**Planning Department  
Transportation Development Services**

**Re: Retail Shops Center – 5400 Central Ave SE**  
**Certificate of Occupancy – Transportation Development**  
Engineer's/Architect's Stamp dated 03-01-14 (K18-D104)  
Certification dated 12-08-14

RE: TRAFFIC CIRCULATION LAYOUT - RETAIL SHOPPING CENTER, 5400 CENTRAL AVE. S.E.,  
ARCHITECT'S STAMP DATED 3/1/14 (MARK UP 3/5/14) ( K18-D104) - COA APPROVAL LETTER DATED  
MARCH 5, 2014 - **FINAL SITE CERTIFICATION**

DRAWING TITLE:  
**TRAFFIC CIRCULATION PLAN**

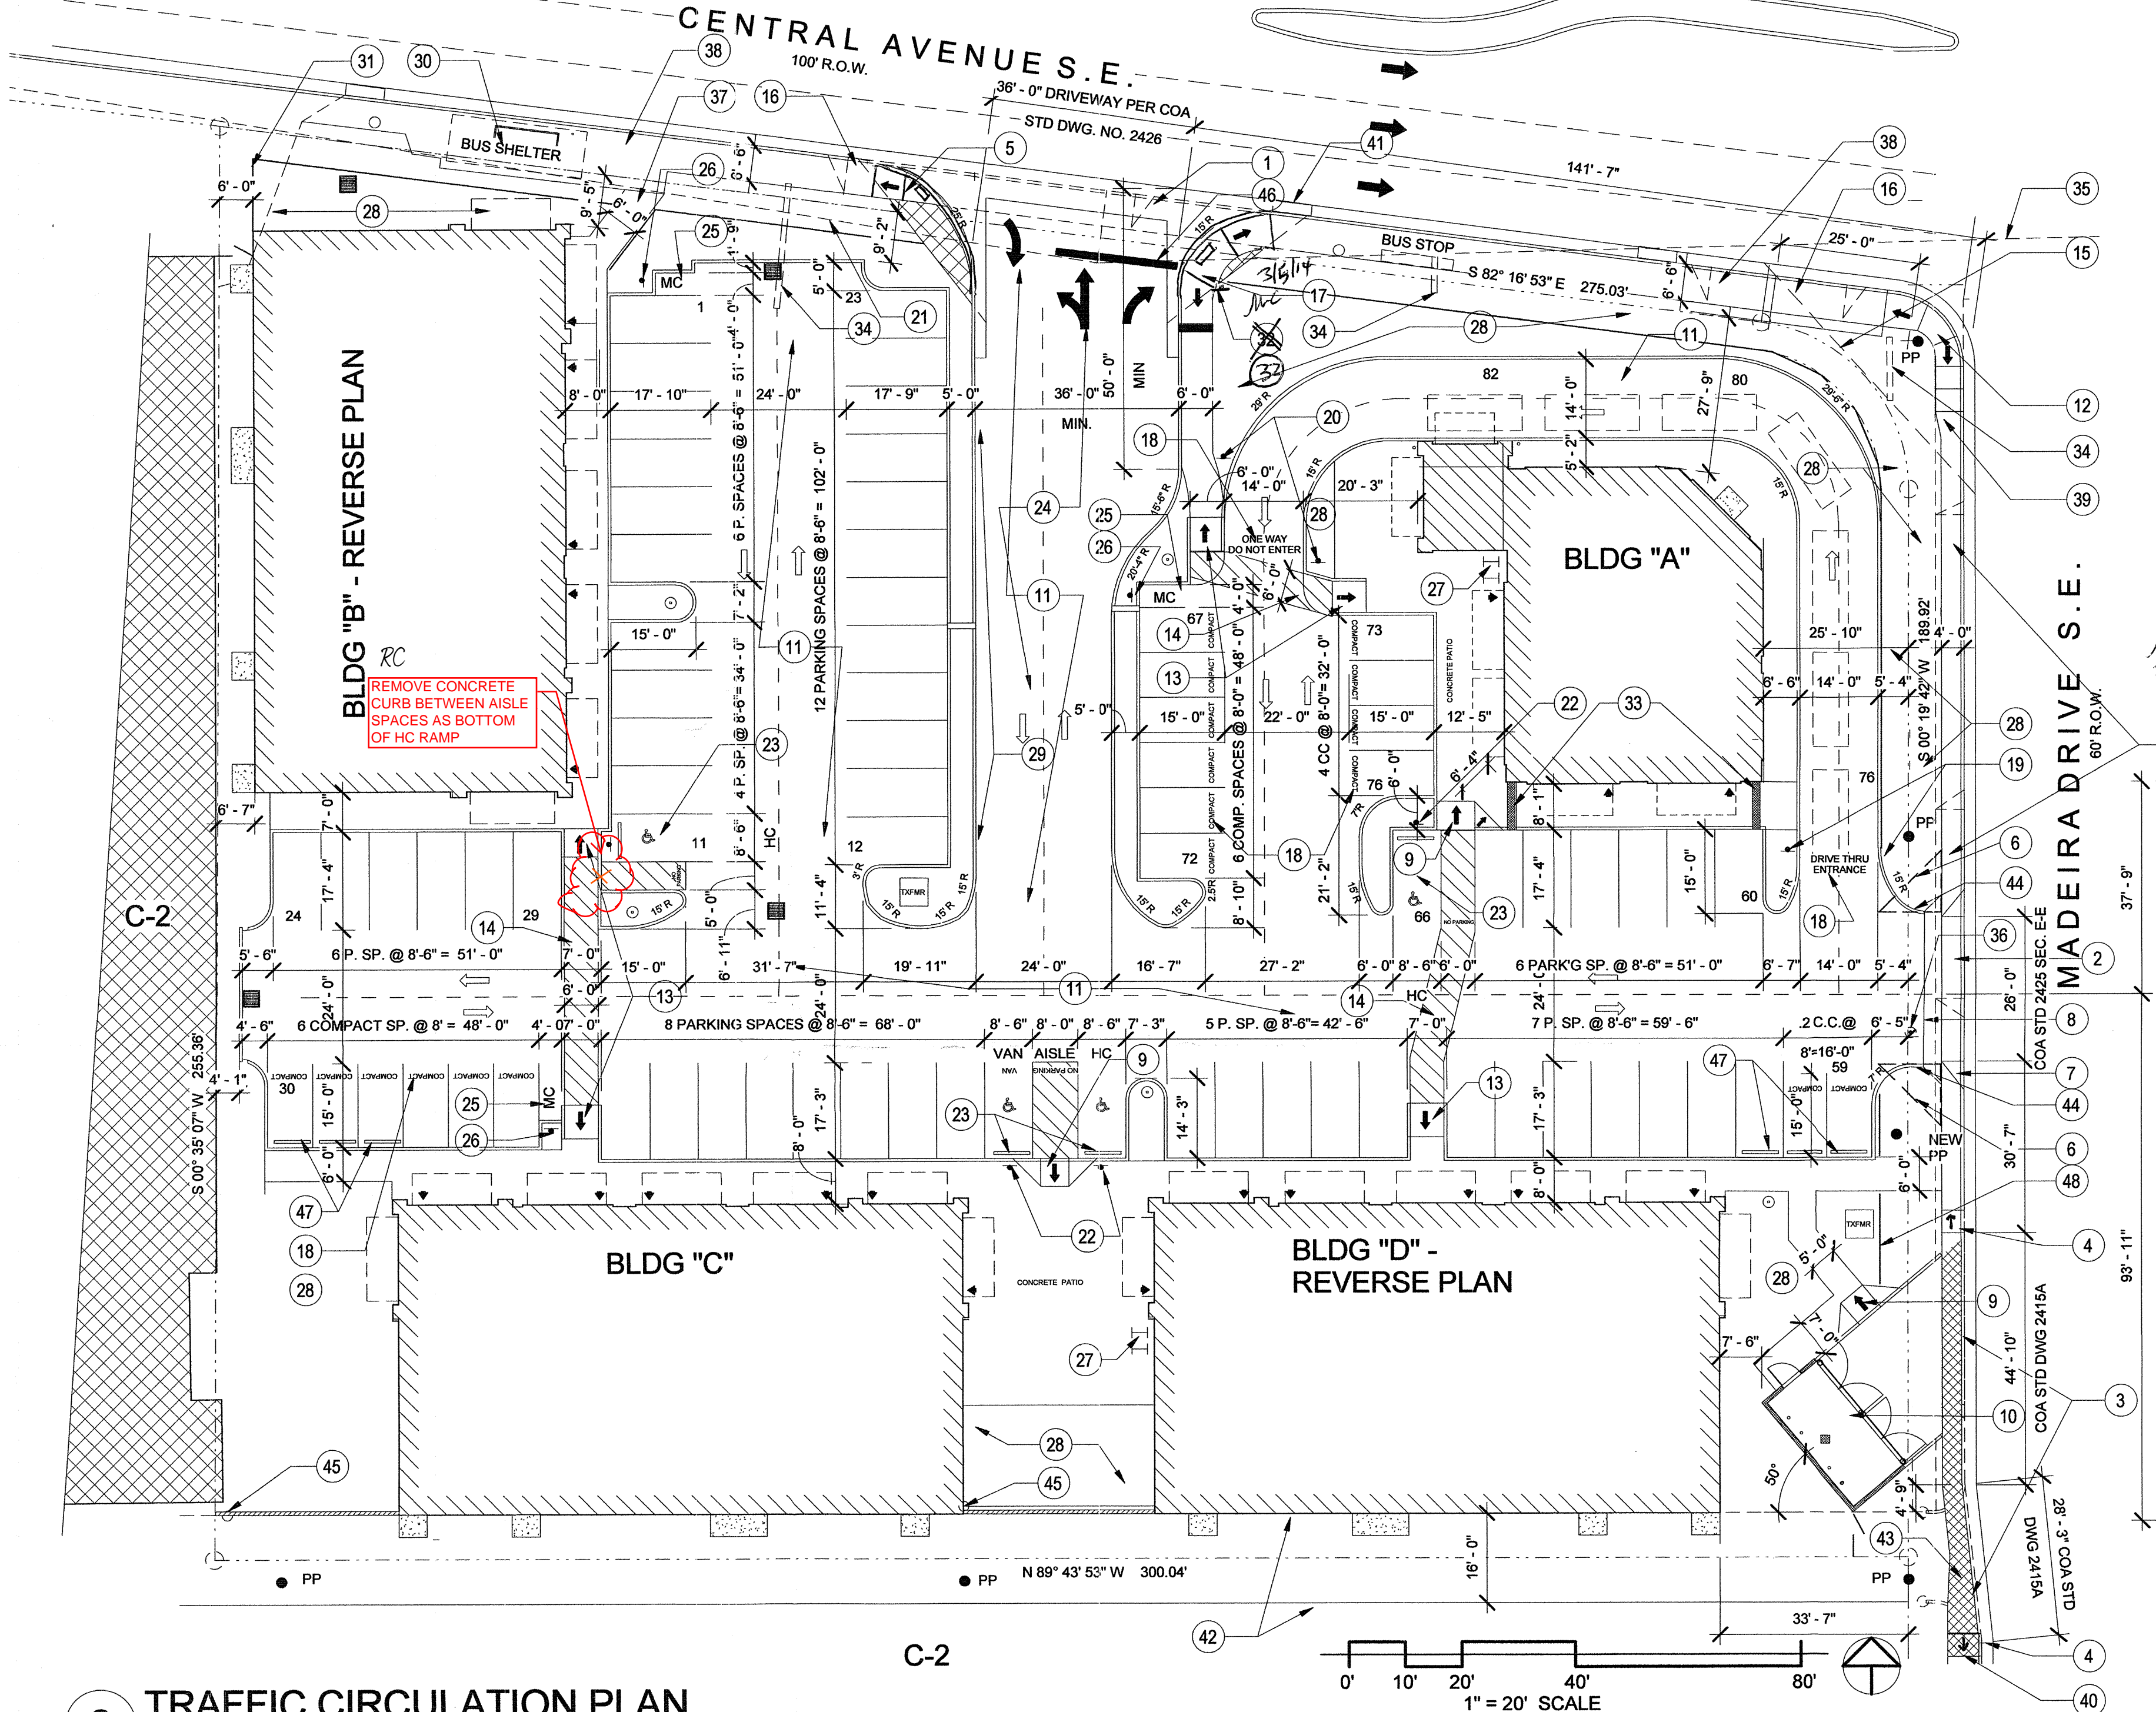
I FURTHER CERTIFY THAT I HAVE PERSONALLY VISITED THE PROJECT SITE ON  
DECEMBER 6, 2014 AND OBSERVED SOME MINOR DEPARTURES FROM THE ORIGINAL DESIGN  
DOCUMENT. THE WROUGHT IRON FENCE INSTALL ( NOTE 48) SHALL TAKE PLACE UPON  
REMOVAL OF THE CONSTRUCTION FENCE. THE CONCRETE CURB AT THE HANDICAP PARKING  
SPACE AISLE ON THE SOUTHEAST CORNER OF BUILDING "B" WAS STILL IN BUT SHALL BE  
REMOVED. SEE EDITED ORIGINAL DESIGN DOCUMENT.
